UNITED STATES  
NUCLEAR REGULATORY COMMISSION  
WASHINGTON, D.C. 20555-0001

SAFETY EVALUATION REPORT

Docket No. 72-1026  
FuelSolutions™ Storage System  
Certificate of Compliance No. 1026

**Figure 4-3 Flow Pattern for Vertical Canister**

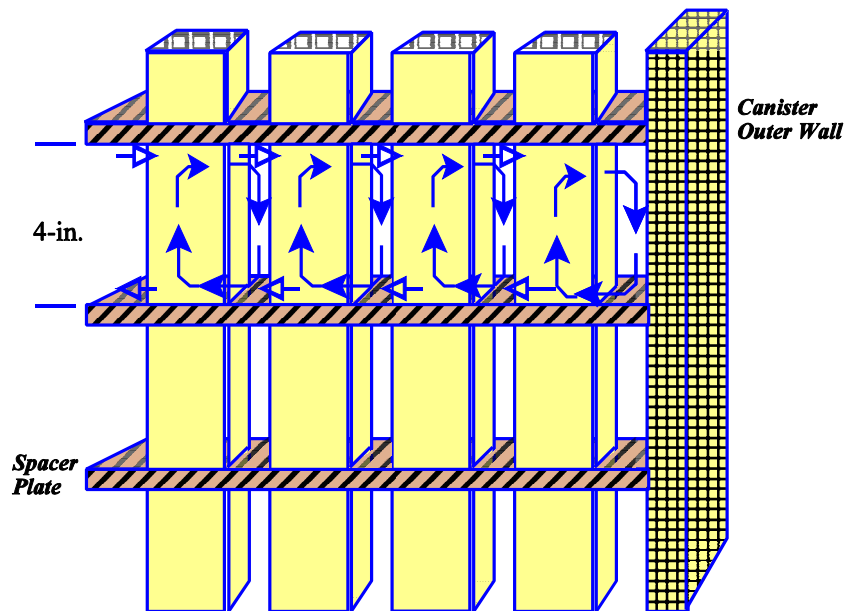
As addressed in Section 4.2.2 of this SER, helium backfill is used in the canister to optimize the heat transfer rate from the fuel to the canister wall and to provide an inert atmosphere to limit the potential for degradation of the internal components. The heat transfer effectiveness of the helium gas was demonstrated on full scale casks at the INEEL. However, the FuelSolutions Canister Storage System has one significant design difference when compared to the tested canisters. Spacers within the FuelSolutions canister limit the natural circulation of helium coolant to the distance between the spacers (e.g., natural convection does not flow from the bottom to the top of the cask outside the fuel assembly region, See Figure 4-3). This limits the buoyancy driving head that can influence the helium velocity. A lower buoyancy head can restrict the maximum velocity of the helium gas. A lower helium velocity has the potential for lowering the convective heat transfer rates. This issue led the staff to question the degree of natural circulation cooling provided in the FuelSolutions design and the ability of the vendor to adequately calculate the heat transfer and helium flow characteristics inside the FuelSolutions canister.

To resolve this technical issue, the staff, with the assistance of the PNNL, performed independent analyses using the COBRA-SFS computer code to augment the validation of the applicant's analytic conclusions. The COBRA-SFS computer code was validated with all of the spent fuel casks tested at the INEEL facility. The results of the COBRA-SFS and SINDA/FLUINT analyses are described in the following paragraphs.

Figure 4-4: COBRA-SFS Predictions of FuelSolutions W21 Storage System Radial Temperatures using BFS Level of Enhanced Heat Transfer Between Spacers

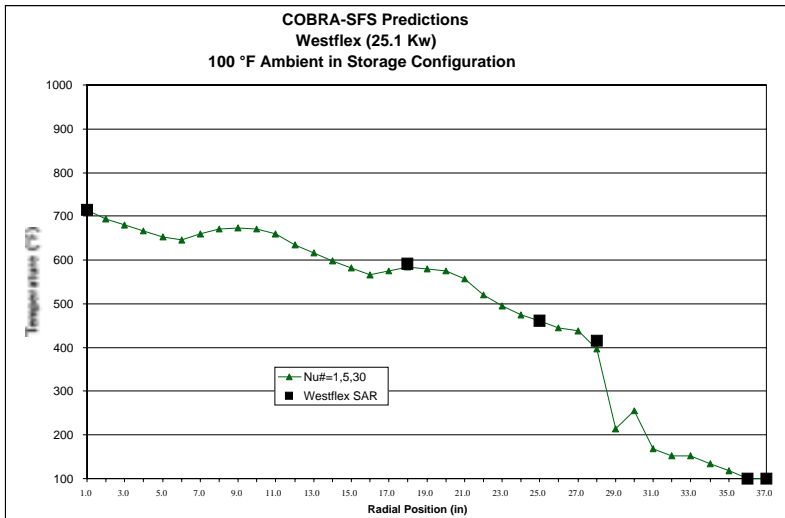
The COBRA-SFS model for the W21 canister was developed from the information presented in the SAR. Two base simulations (i.e., Cases 2 and 3) were performed. First a COBRA-SFS model was developed to treat the radial heat transfer in the regions between the horizontal spacer plates using a similar Nusselt number approach as applied by The applicant. This validated the staff's input model for COBRA-SFS code as providing similar results compared to the applicant's analyses. Next, although data exists for a range of spent fuel storage systems, there is no comparable full scale cask thermal performance data with multiple horizontal spacers, as designed into FuelSolutions. However, data for enhanced heat transfer due to natural convection between plates was identified by The applicant (e.g., Figures 4.4-4 and 4.7-5 in the WSNF-201 SAR). As an independent confirmatory calculation of the physics that exists in the FuelSolutions design, the staff requested PNNL to confirm, through detailed analyses, the thermal characteristics or response of the helium heat transfer mechanisms (e.g., flow and heat transfer rates) that occurs between the spacers.

The first base simulation (Case 2) COBRA-SFS model using the enhanced Nusselt number correlation in between the spacer regions duplicated the applicant's predictions extremely well. The results are presented in Figure 4-4. The radial temperatures are provided at the peak axial temperature level of the spent fuel cladding in the center assembly for all of the components, with the exception of the annulus temperatures, which represent the peak temperature of the flow field which occurs at the inner and outer annulus outlets. For simplicity, only a few points from the FuelSolutions SAR have been provided. Results from the second base simulation (Case 3) COBRA-SFS model are included and presented in Figure 4-5. The radial heat transfer coefficient of the gas between the spacers was treated with a Nusselt number of 3.66, with the exception of the single region that was nodalized in greater detail. It is projected that the peak temperature predicted by the COBRA-SFS model would approach the 715 °F predicted by the BFS model if the flow among all of the spacers was treated in a similarly detailed fashion. The staff, therefore, finds the thermal models used by the applicant acceptable.
